CS Memorandum No. 1411

**Subject:** Configuration Management Board Meeting No. 120

## CMB Meeting Minutes #120

SUBJECT: Configuration Management Board Meeting # 120 – Rev. No. 0

S:\6nas003\m544.1\FinalDesign\Drawing-821\2-Civil\Water Distribution\Sheet Files CP03\M54423WD402.dwg FBayani Wed Jan 26, 2011 - 4:22 pm WD-402

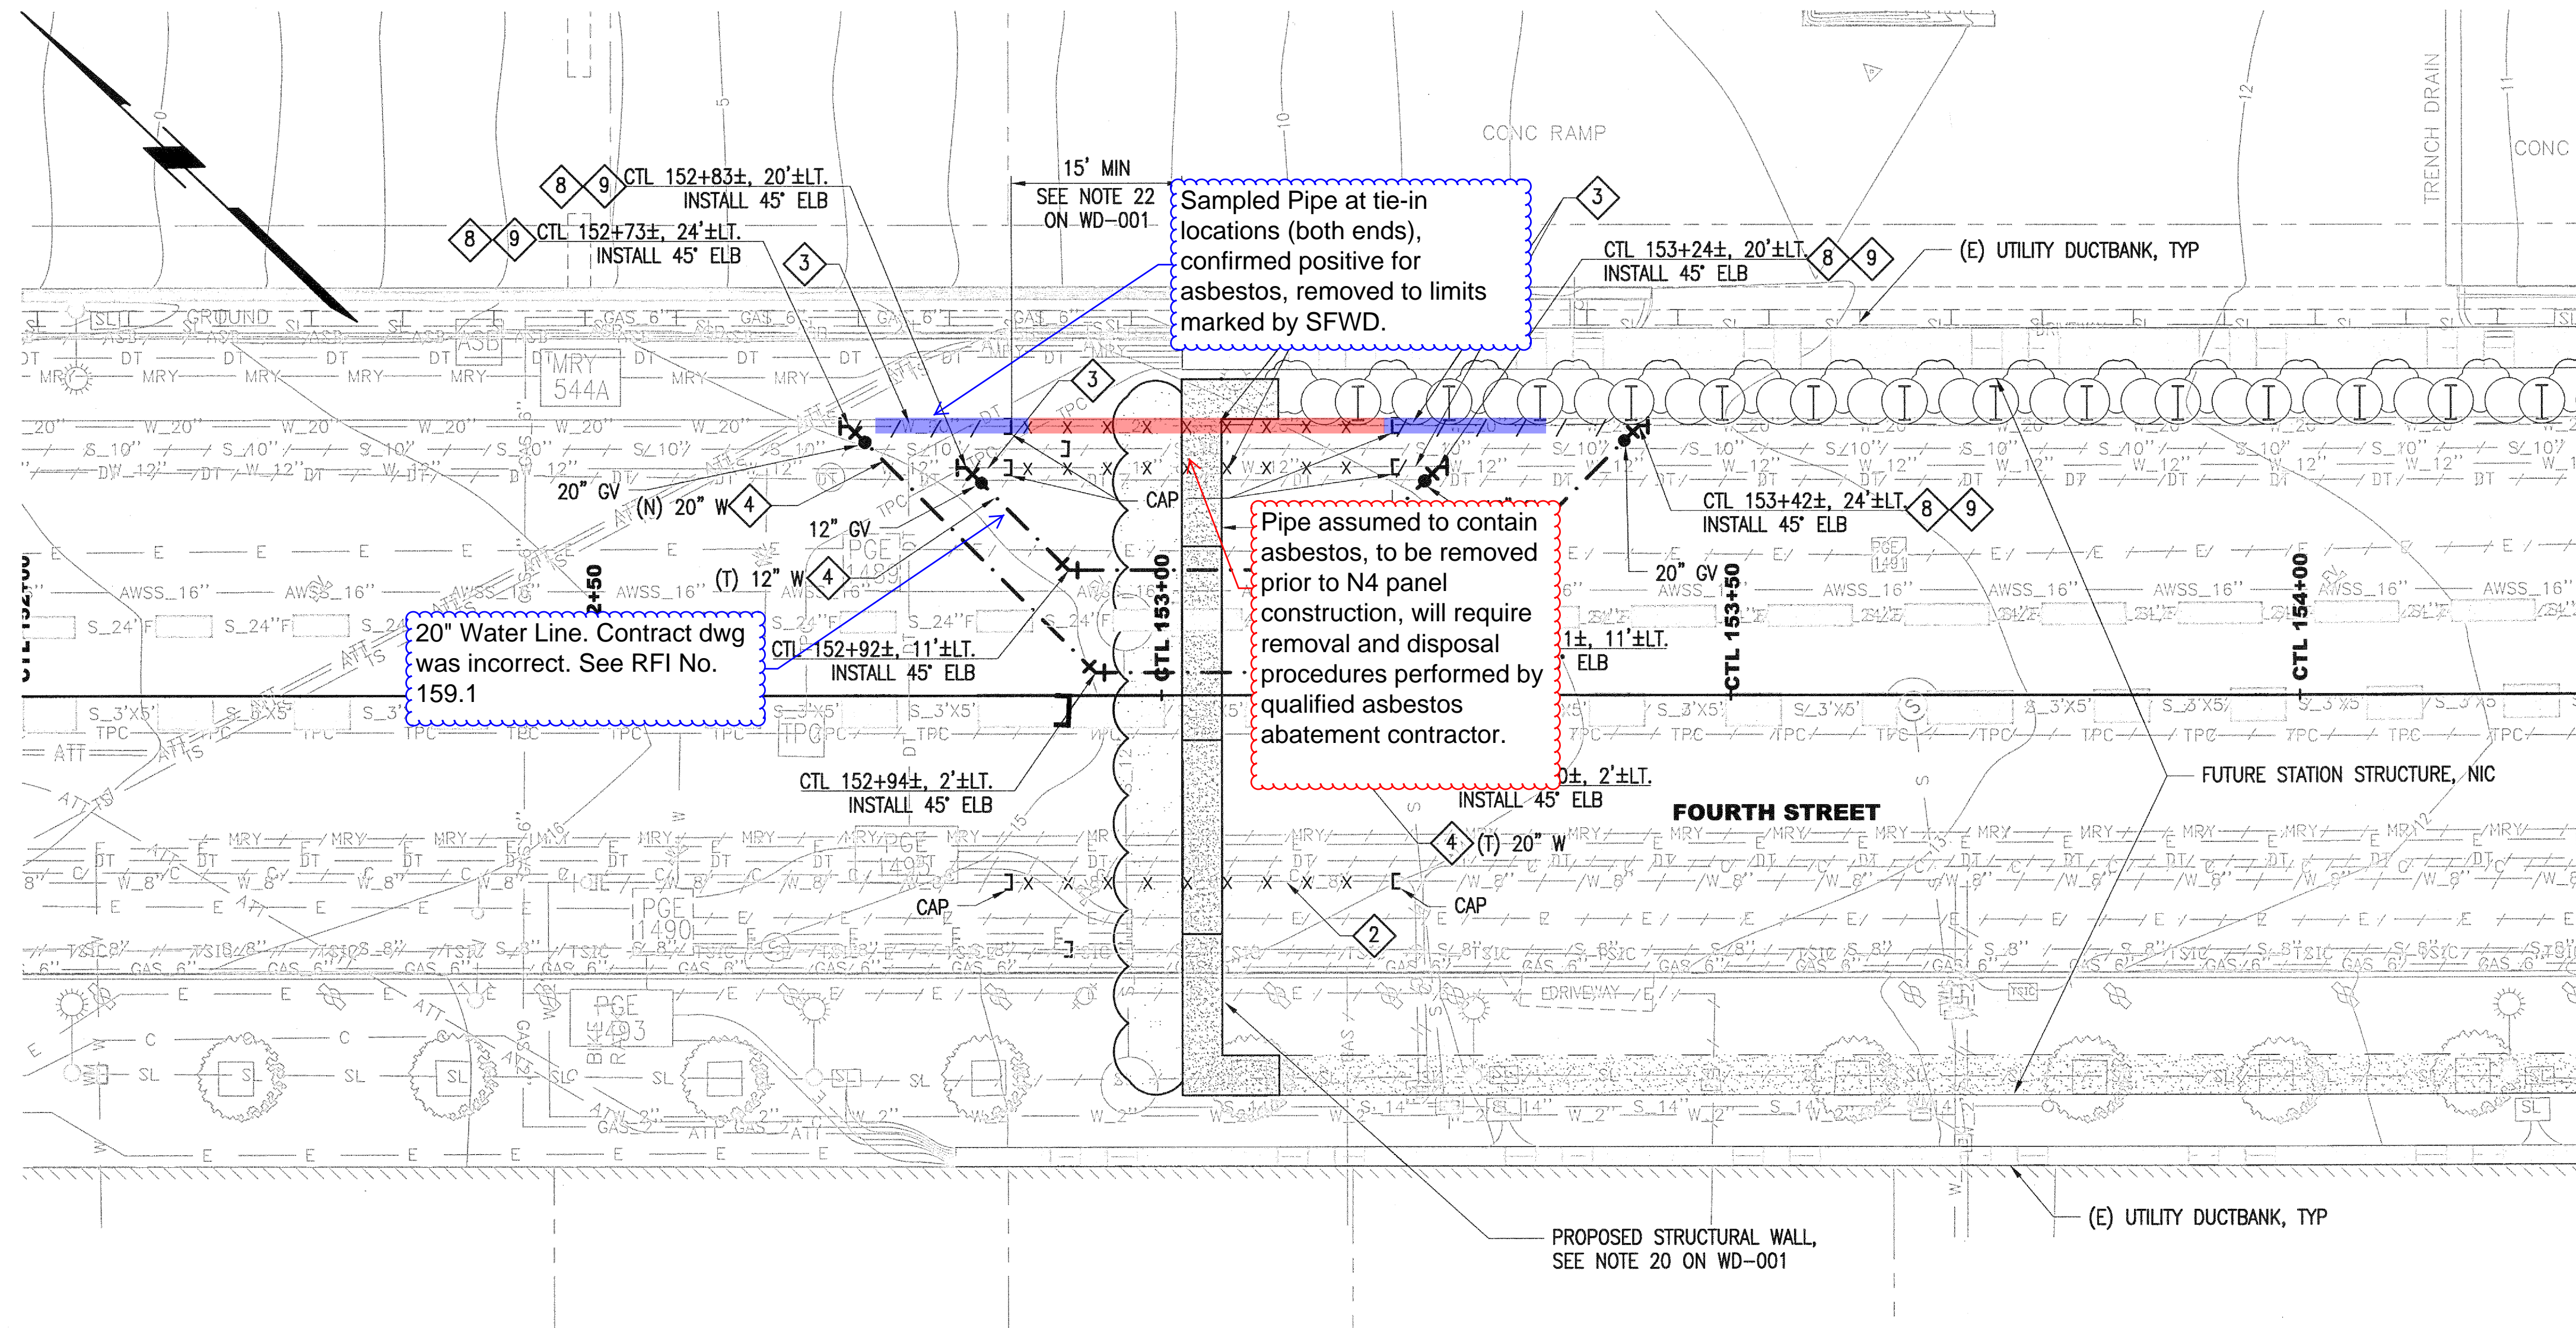
**Justification:** The asbestos wrapping on the existing 20" water line constitute a differing and unforeseen site condition as it is not shown in the Contract Documents, specifically Drawing WD-402 Rev.0 and UD-402 Rev.0. Testing of the asbestos wrapping and asbestos abatement work was required in order for the SFWD to perform water tie-in work. Additional work will be required to perform asbestos abatement on the remaining portions of the water line prior to slurry wall construction. In accordance with Contract Specifications section 01-20-00 an allowance has been established to pay for Environmental Mitigation as needed and directed by the City.

ENSURE ISO CONTRACT  
IS NOTED FOR THIS  
CONDITION

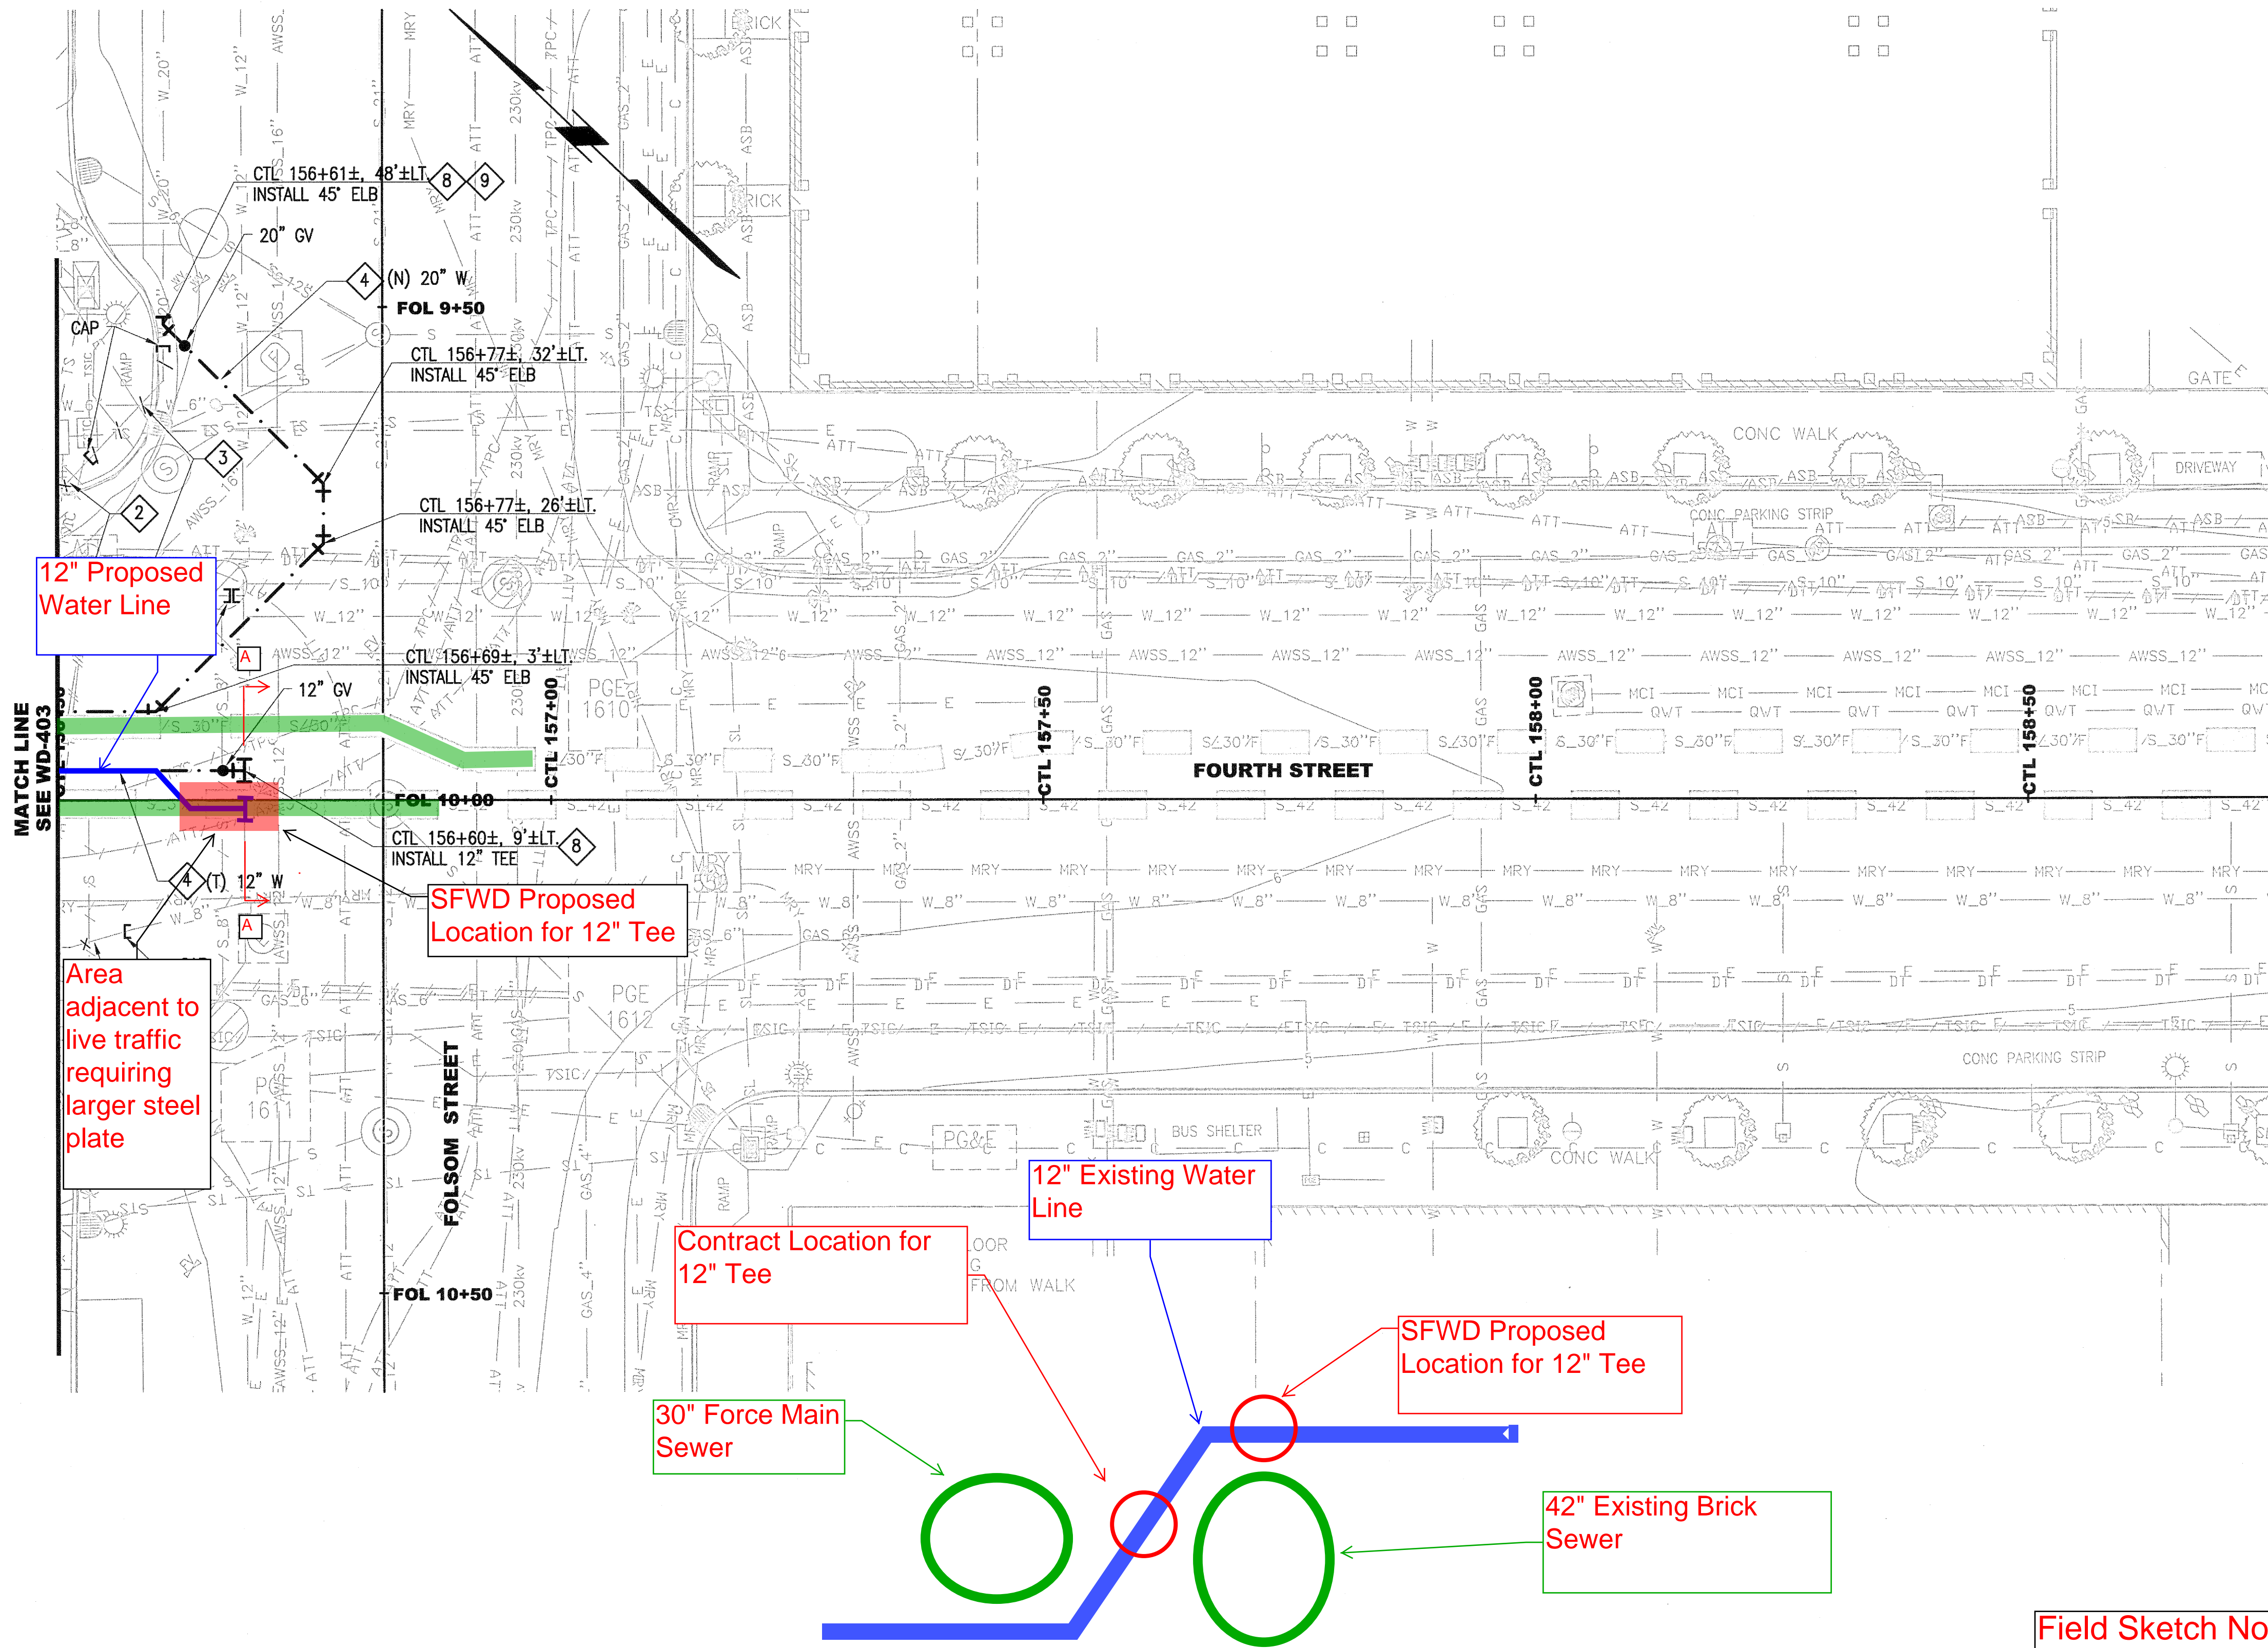
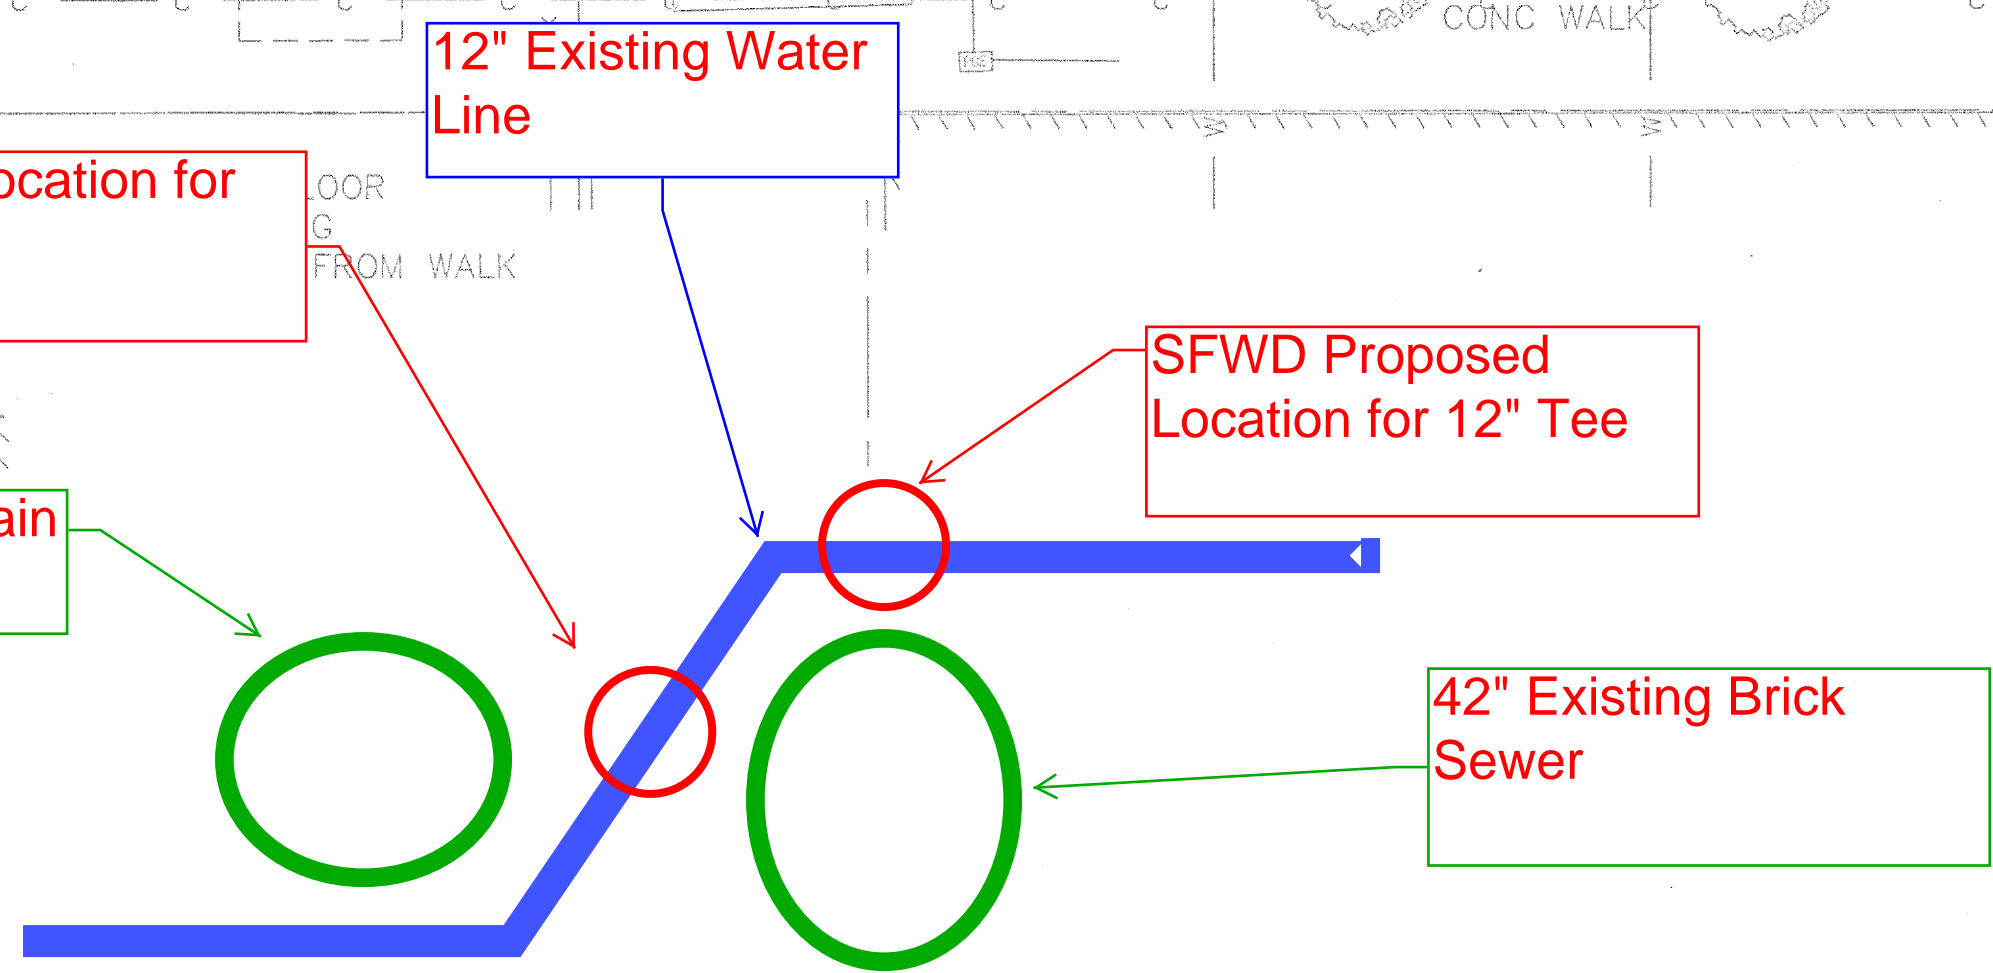
**Facts:** Contract Drawing WD-404 Rev.0 shows the new 12" waterline on the south side of the MOS south headwall to make a tee connection to the existing 12" waterline in Folsom St. Upon exposing the connection location the Contractor encountered a vertical offset in the existing 12" waterline. The vertical offset was due to the presence of an existing 42" brick sewer. At the request of the SFWD and following a meeting with the SFMTA, the Contractor was requested to enlarge the excavation to the west to facilitate SFWD's installation of the new 12" tee connection. See attached sketch FS 1252 - 036 for more details.

**Justification:** The vertical offset discovered in the 12" waterline constitutes a differing and unforeseen site condition as it was not shown in the Contract Documents, specifically Drawing WD-404 Rev.0. The additional work to enlarge the excavation was necessary to facilitate the SFWD's installation of the 12" waterline tee connection.

Additional labor and equipment costs were incurred for additional excavation and backfilling due to the enlarged excavation. As a result of enlarging the excavation to the west a larger steel sheet was also needed to allow traffic to return to the approved configuration at the end of the work day. To handle the larger steel sheet it was necessary for the Contractor to mobilize a larger excavator than was currently being utilized to move the smaller steel plates.
